Cumming Park & Ride (Overview Map)

Hamilton Mill Park and Ride

West Douglas Park & Ride (Overview)

South Operations Facility (Overview)

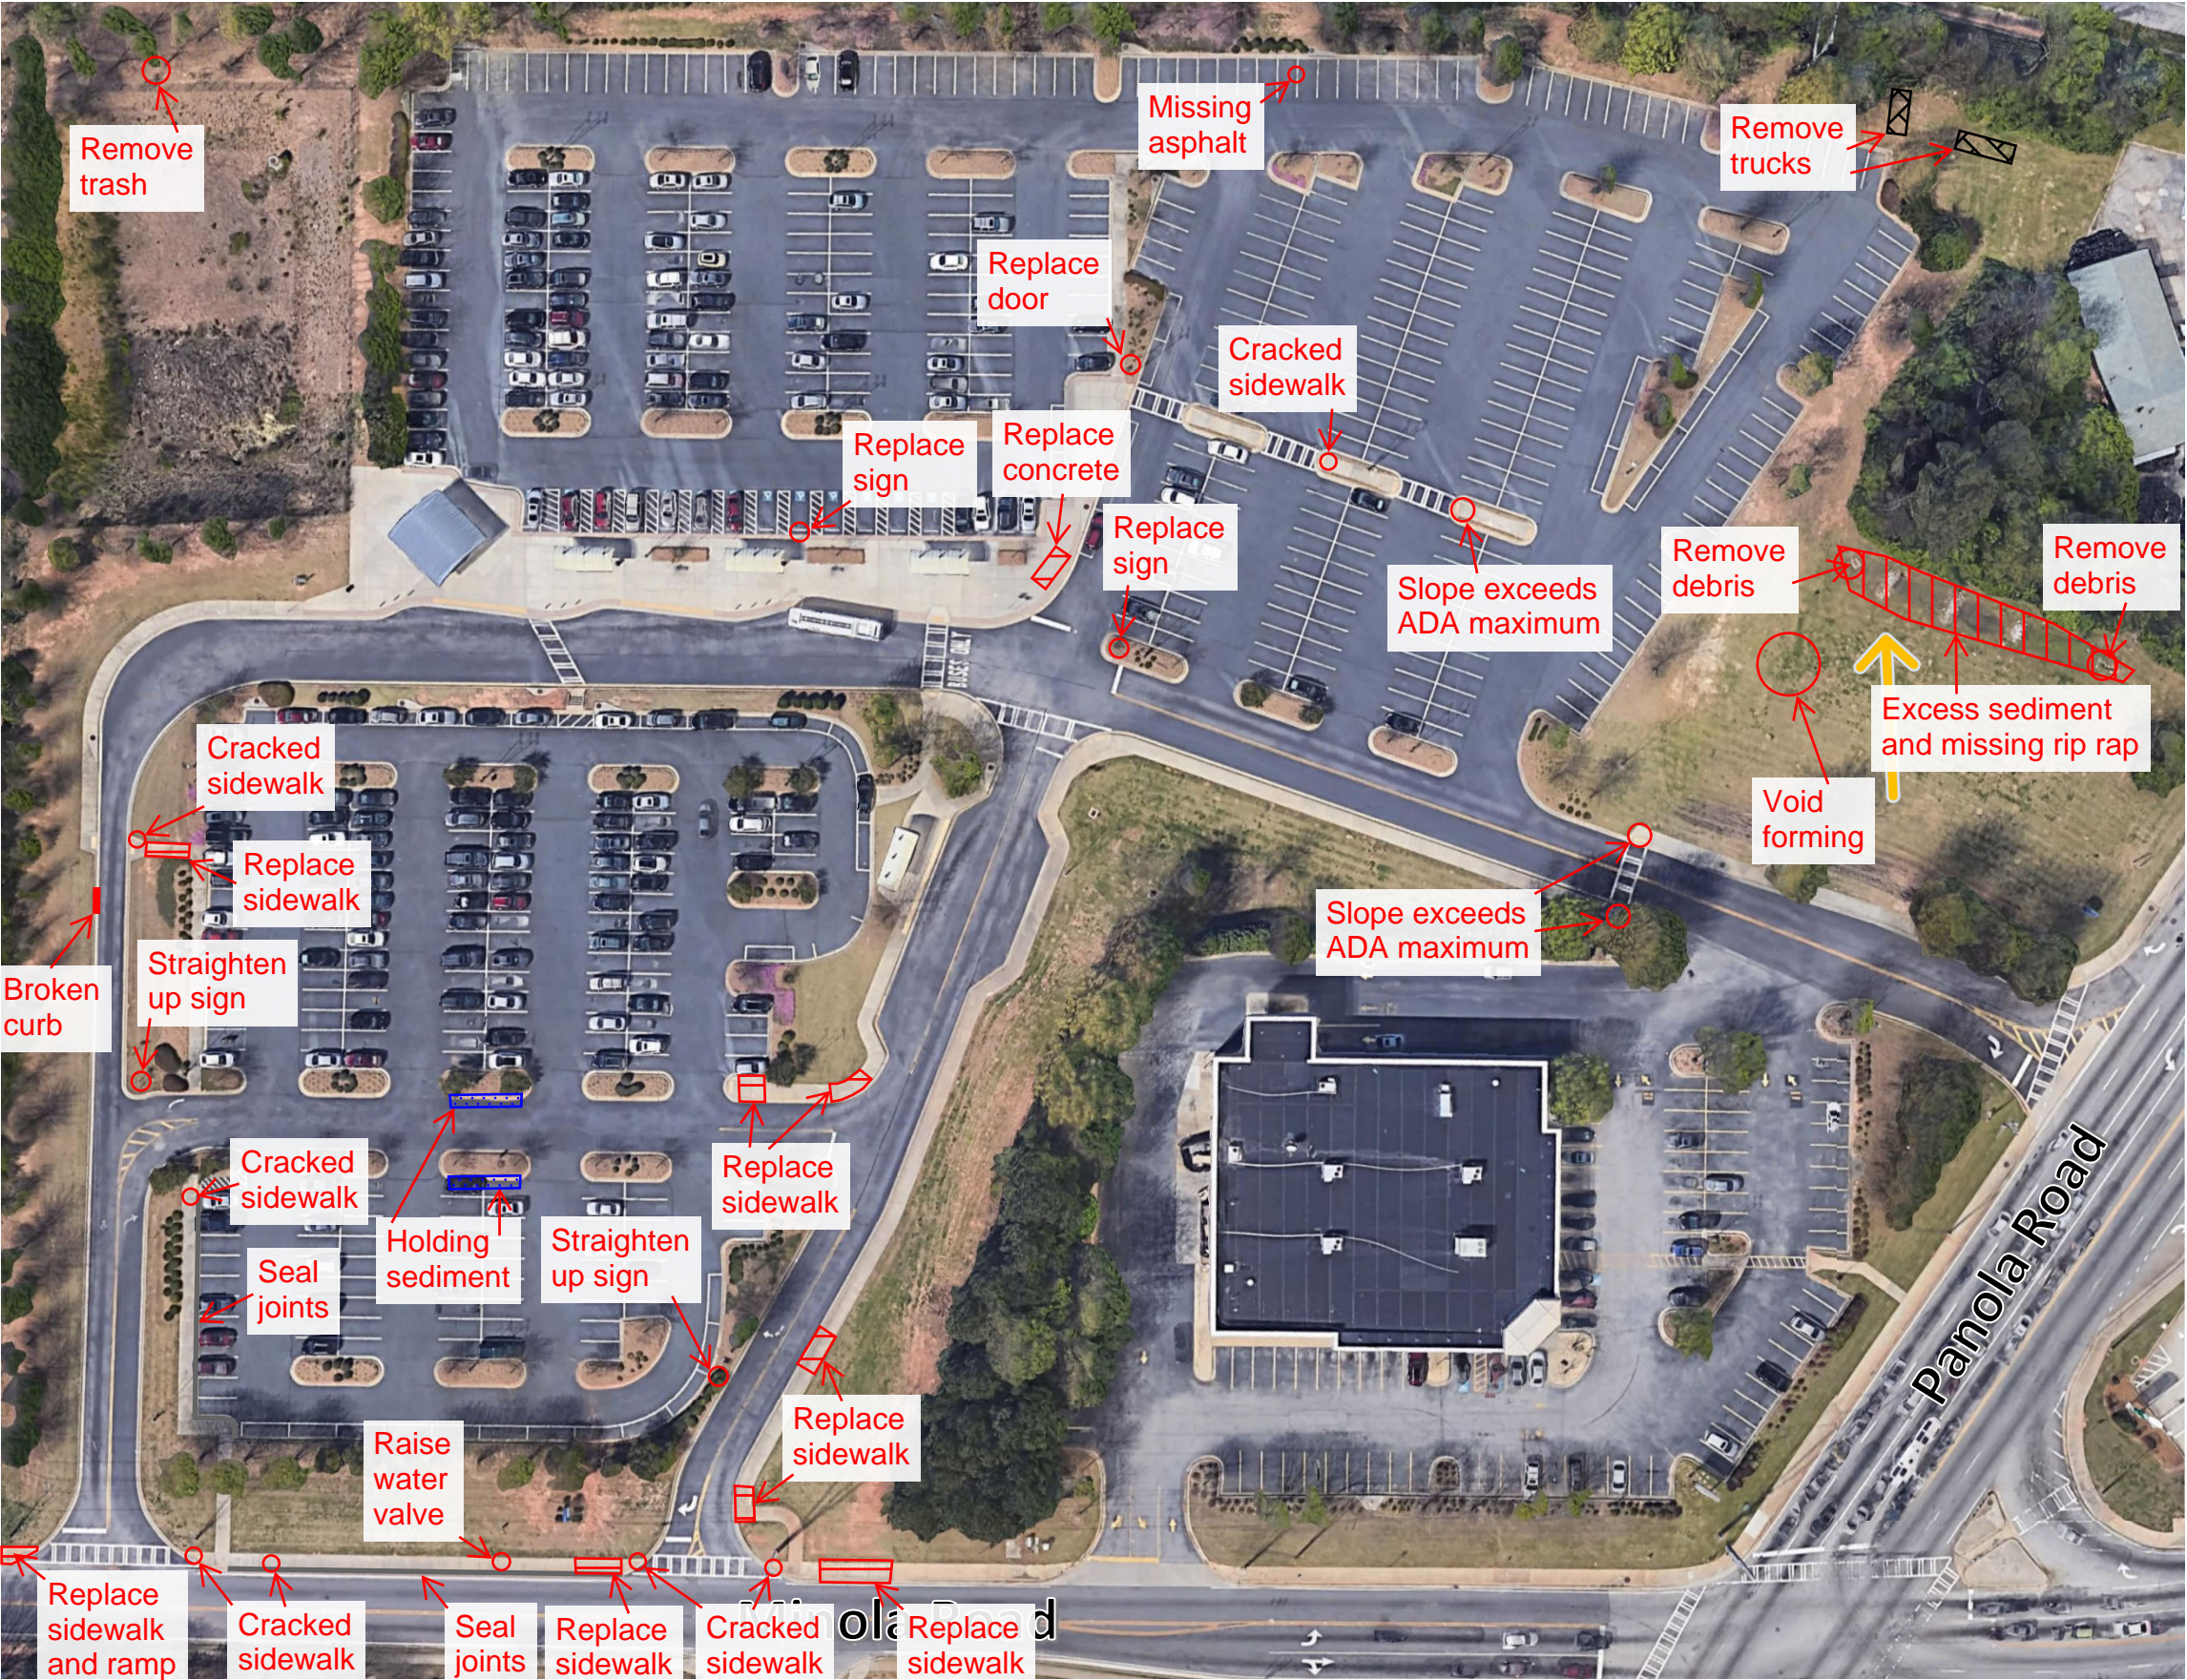
- Cracked curb
- Backfill the hole
- Slope exceeds ADA maximum
- Replace sidewalk
- Exposed post
- Cracked Curb
- Replace sidewalk and ramp
- Seal Joints
- Backfill the hole
- Replace sidewalk
- Seal crack at ramp
- Seal Joints
- Replace sidewalk

Seal / Joints

~~Replace sidewalk~~
